ADDENDUM NO. 03

Date: 09.19.2025

Project: Sheridan HS and MS School Renovation Project

The Hagerman, Inc portion of this Addendum consists of the following information:

DRAWING NUMBER A201D

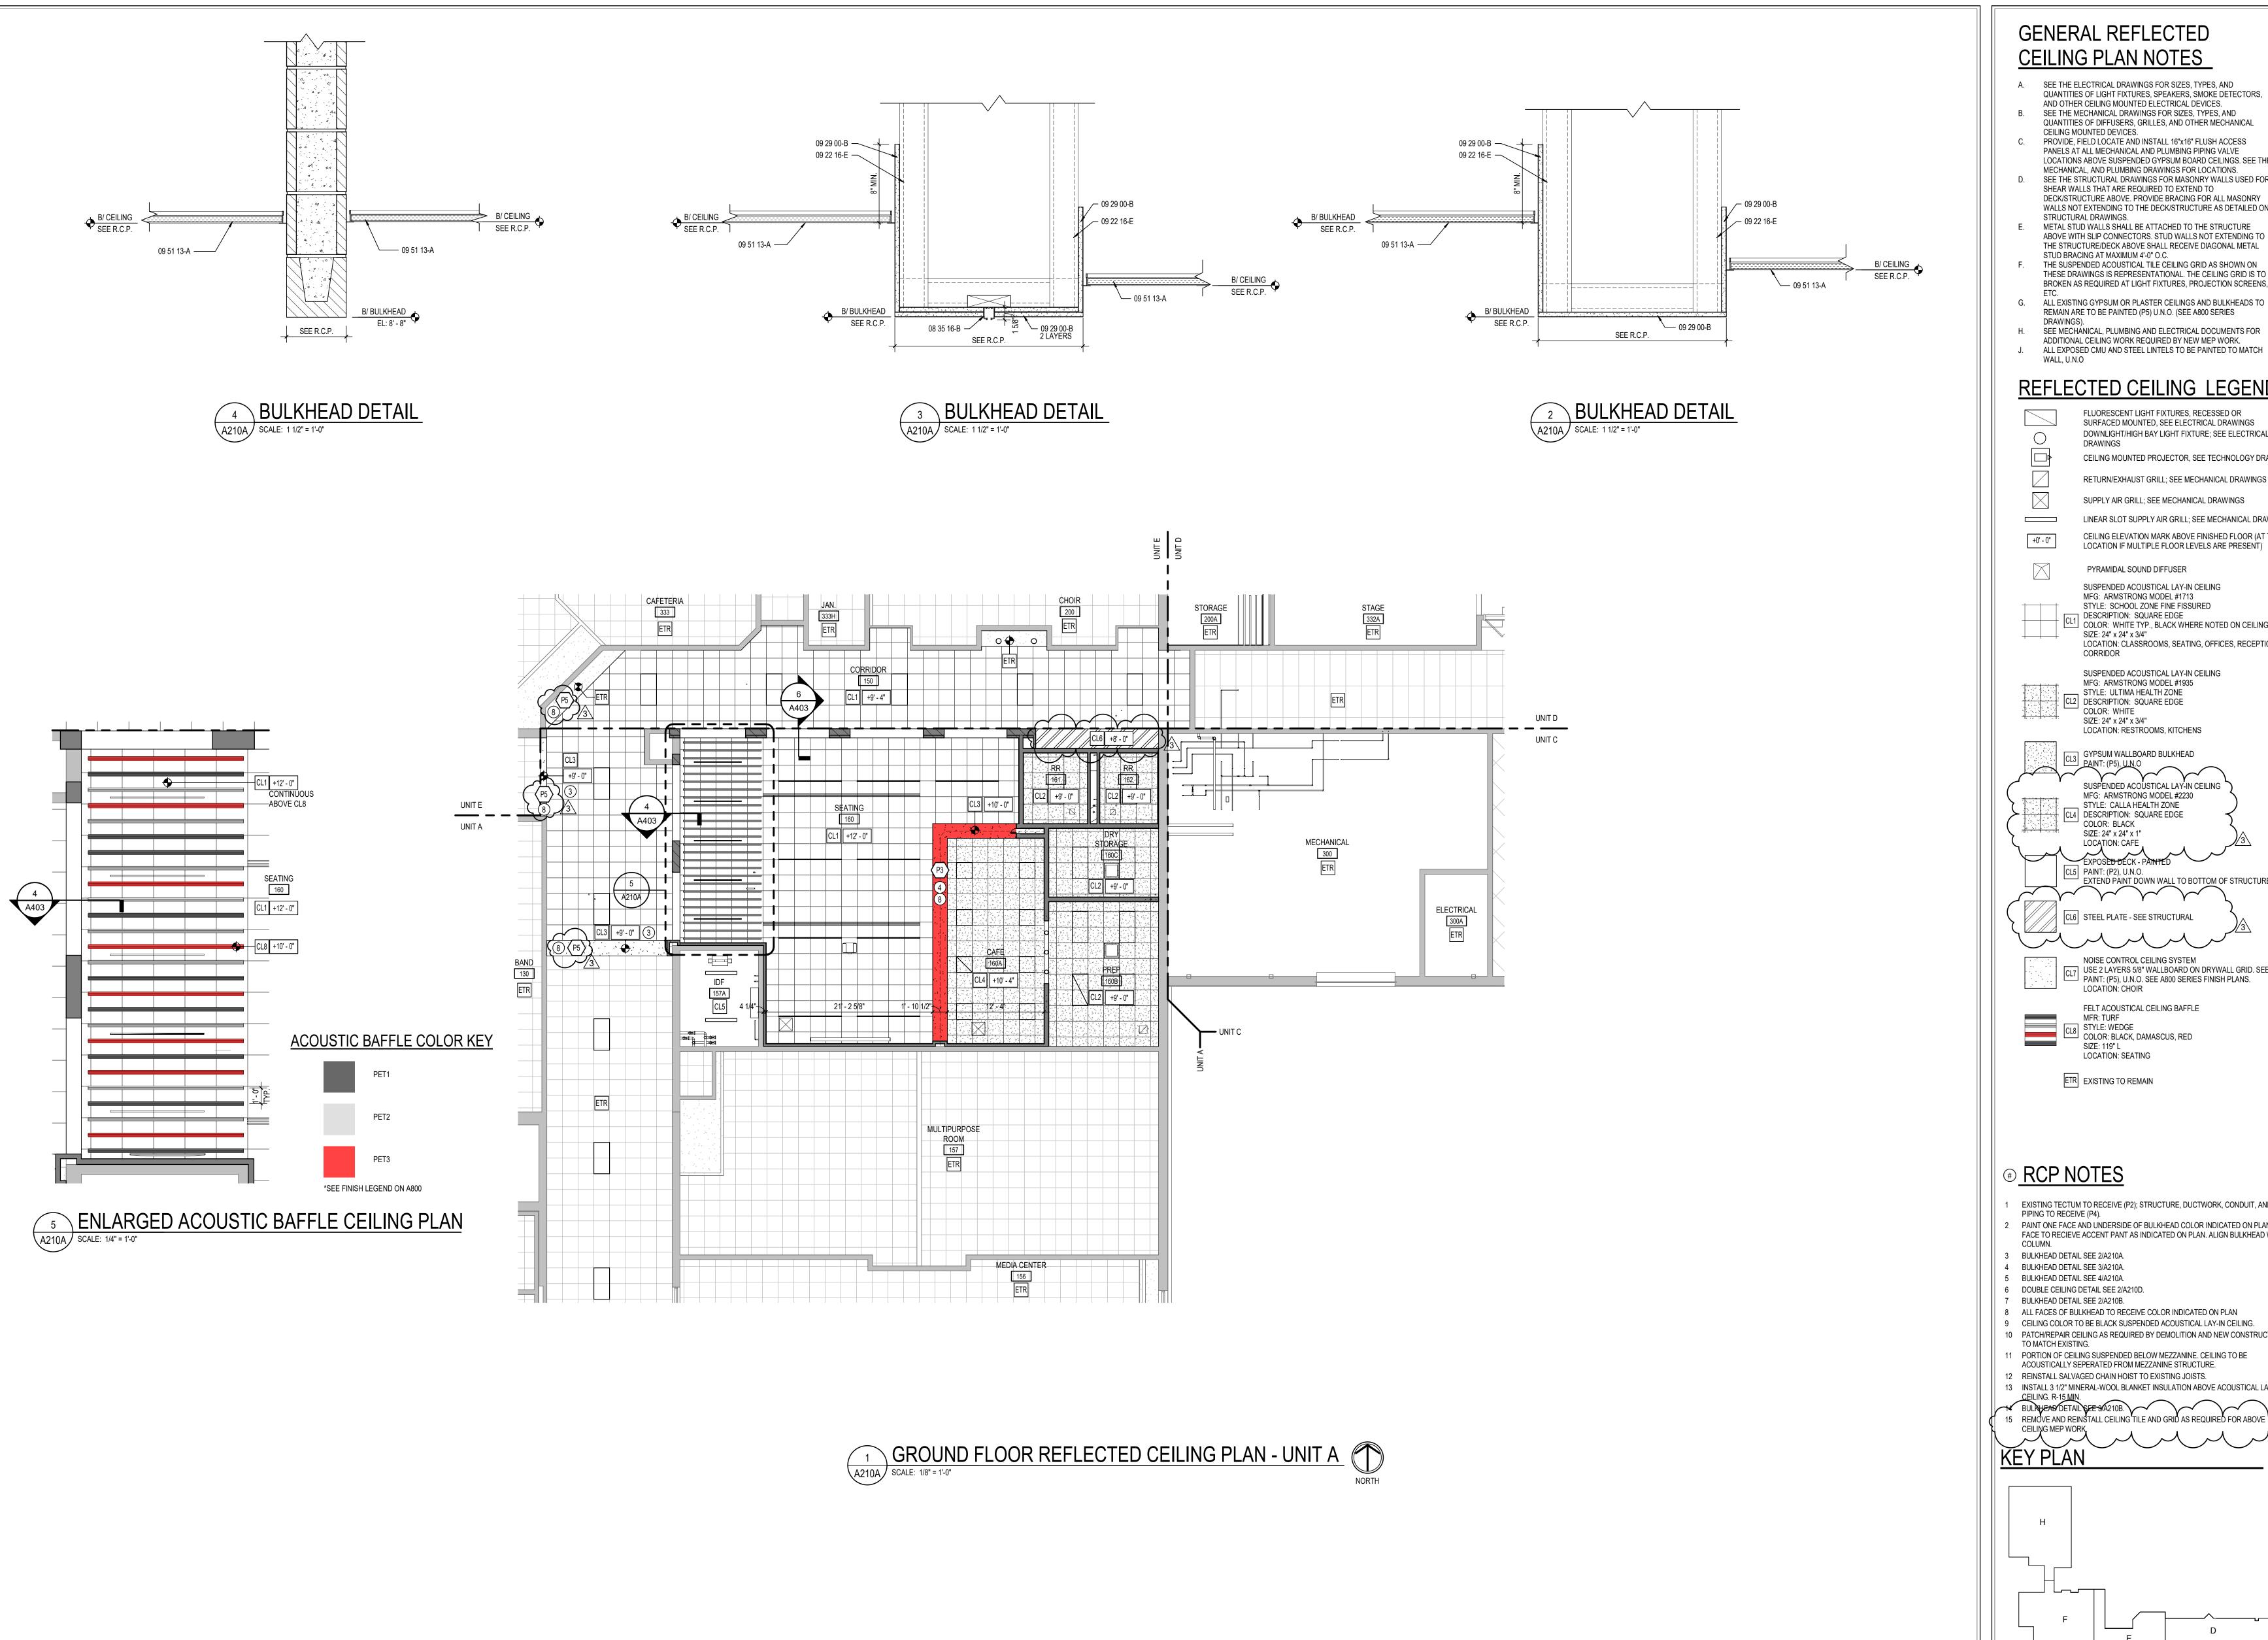
3.9 A201D – GROUND FLOOR PLAN – UNIT D

- A. Add note 17 to Practice Rooms 318A, 318B, 318C.
- B. Add note 17 to Plan Notes.
- C. Revise wall types in Practice 318A and Practice 318B as shown.
- D. Add chase to Classroom 217 as shown.

CEILING PLAN -

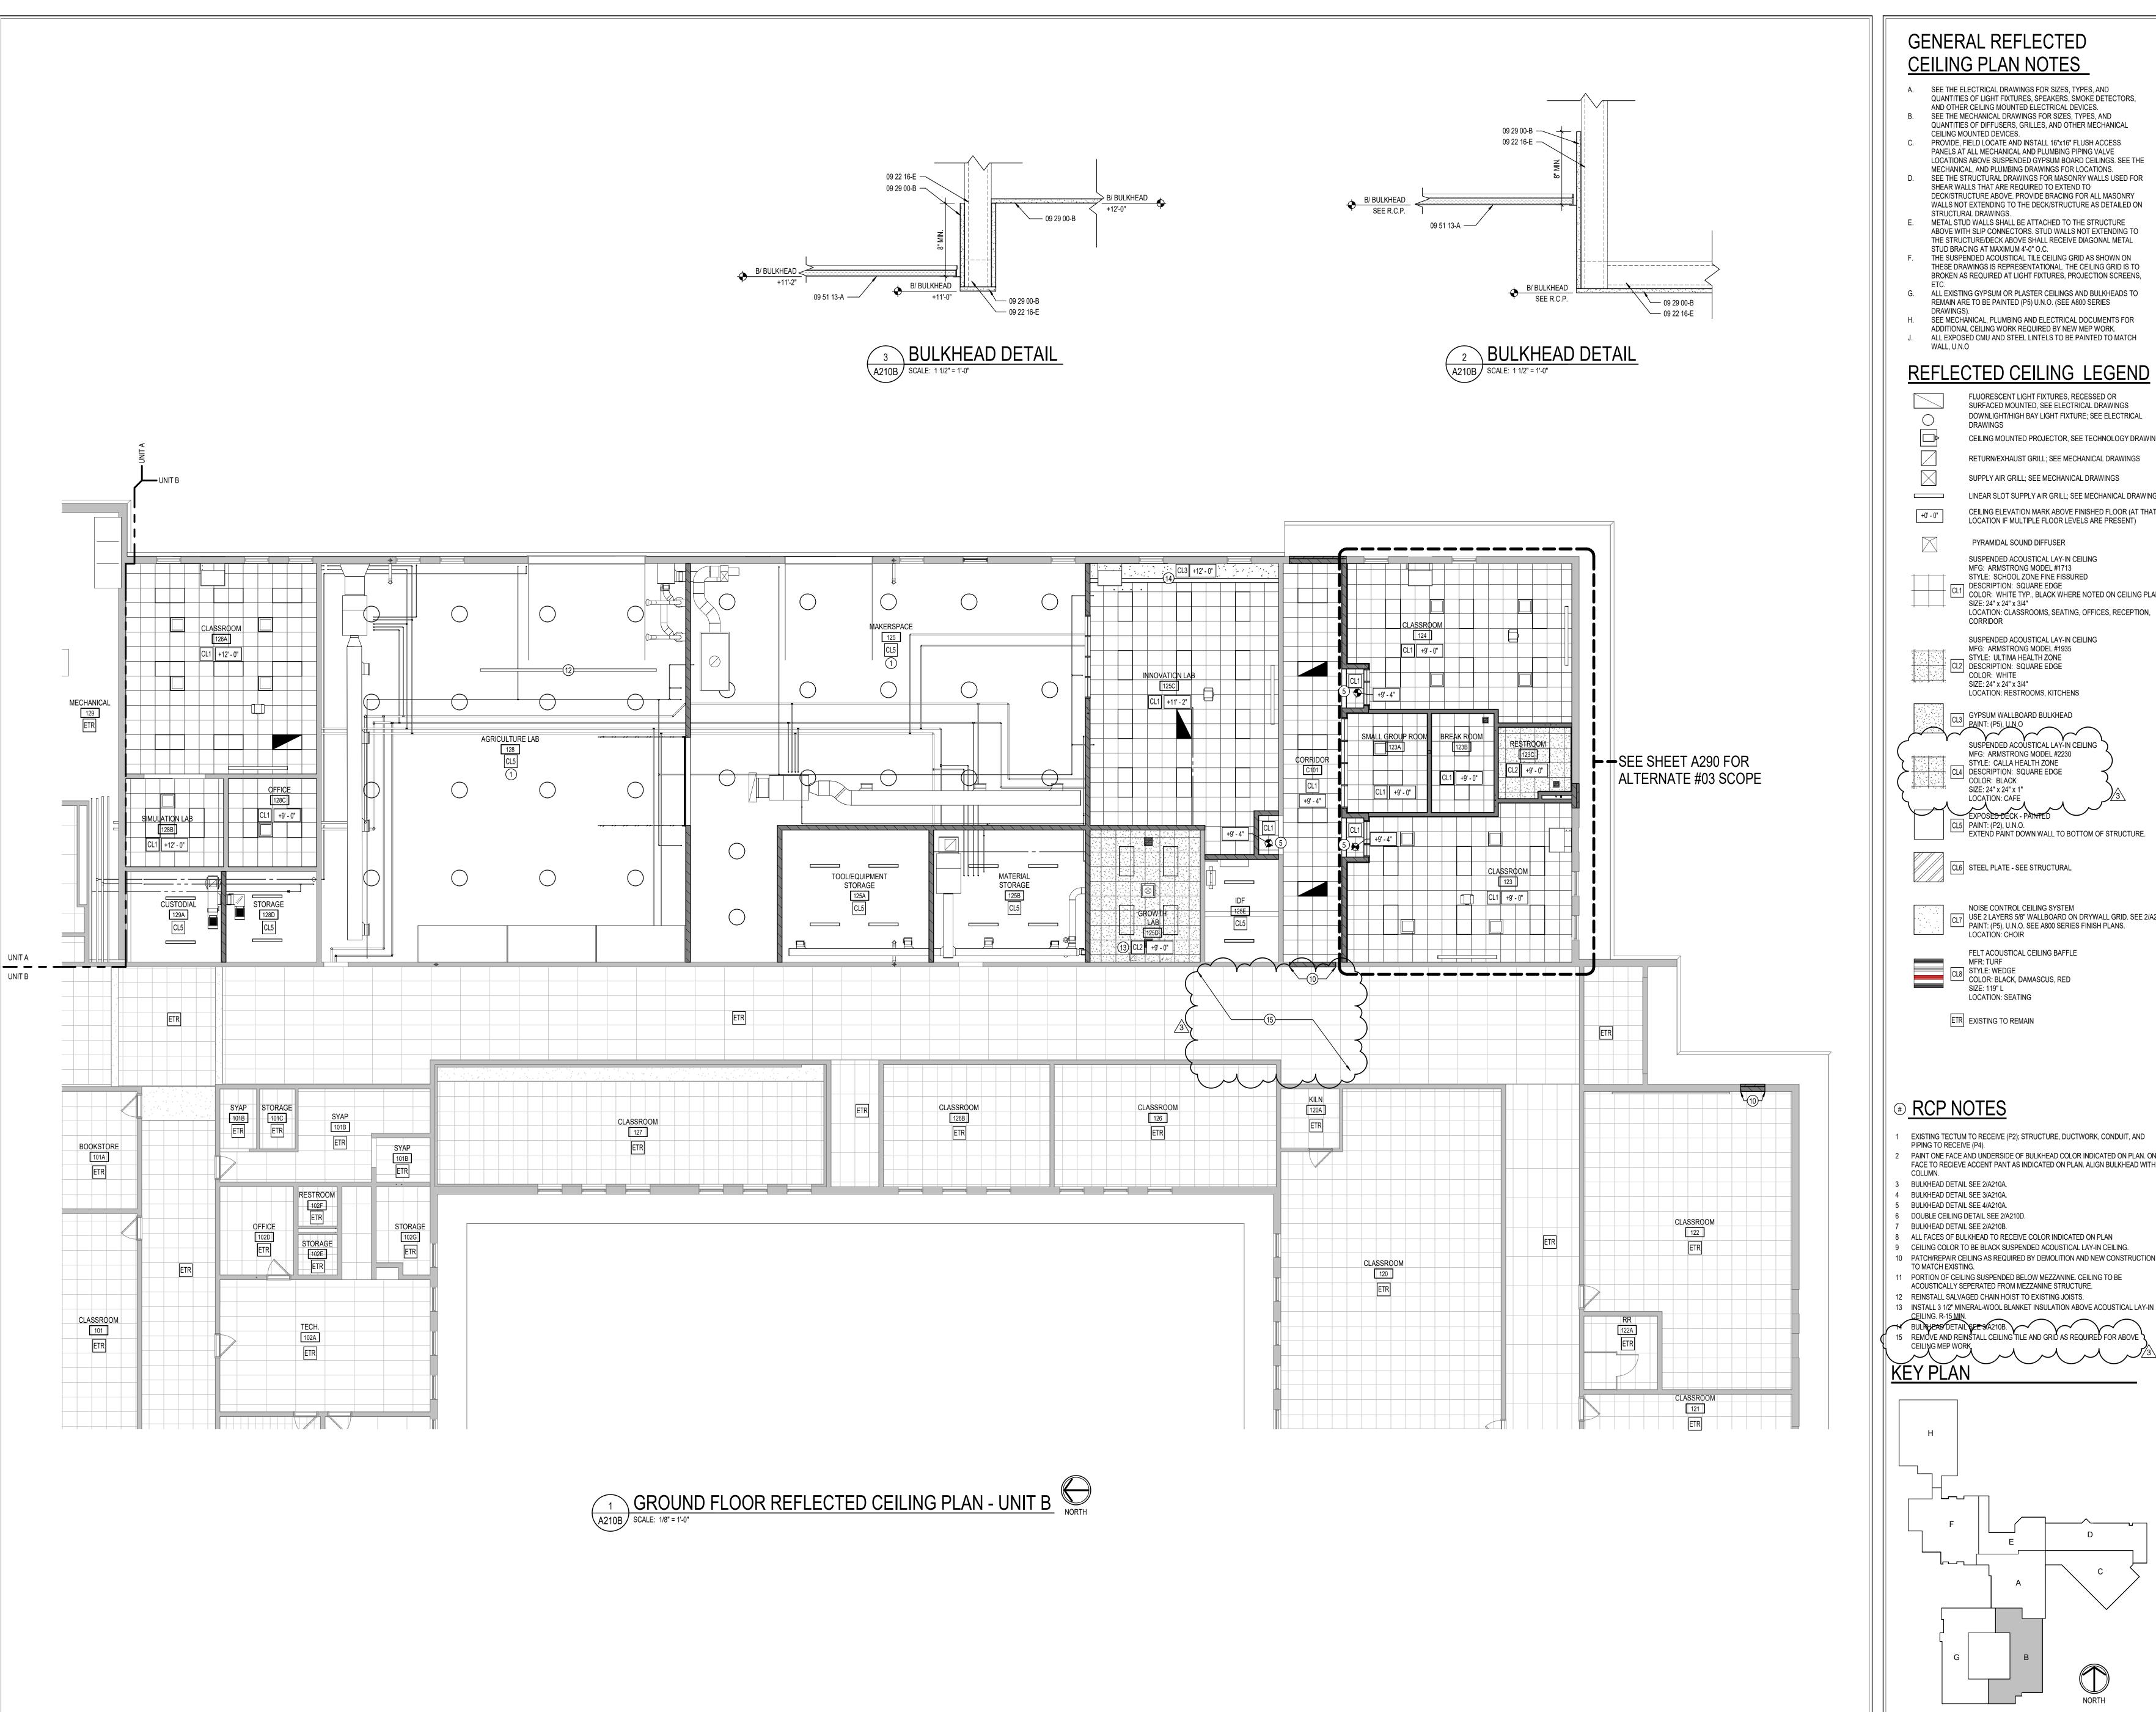
- 20.Bid Item #02 Masonry Contractor shall install and be responsible for the revised "CL6" ceiling type on Drawings A210A, A210B, and A210D. Refer to section 6 on Drawing S701.

- E. Add note 18 to Plan Notes.
- 3.10 <u>A210A GROUND FLOOR REFLECTED CEILING PLAN UNIT A</u>
 - A. Revise CL4 as shown.
 - B. Add CL6.
 - C. Revise bulkhead outside restrooms as shown.
 - D. Revise bulkhead notes for painting as shown.
- 3.11 A210B GROUND FLOOR REFLECTED CEILING PLAN UNIT B
 - A. Revise CL4 as shown.
 - B. Add note 15 to corridor.
 - C. Add note 15 to RCP Notes.
- 3.12 <u>A210D GROUND FLOOR REFLECETED CEILING PLAN UNIT D</u>
 - A. Revise CL4 as shown.
 - B. Add note 15 to corridor.
 - C. Add note 15 to RCP Notes.
- 3.13 A220B ROOF PLAN UNIT B ALTERNATE #02 SCOPE
 - A. Add text note to read "STRUCTURALLY SLOPED TECTUM ROOF DECK."
- 3.14 A220C ROOF PLAN UNIT C ALTERNATE #01 SCOPE
 - A. Add text notes to read "STRUCTURALLY SLOPED STEEL ROOF DECK."
- 3.15 A220D ROOF PLAN UNIT D ALTERNATE #01 SCOPE
 - A. Add text notes to read "STRUCTURALLY SLOPED STEEL ROOF DECK."
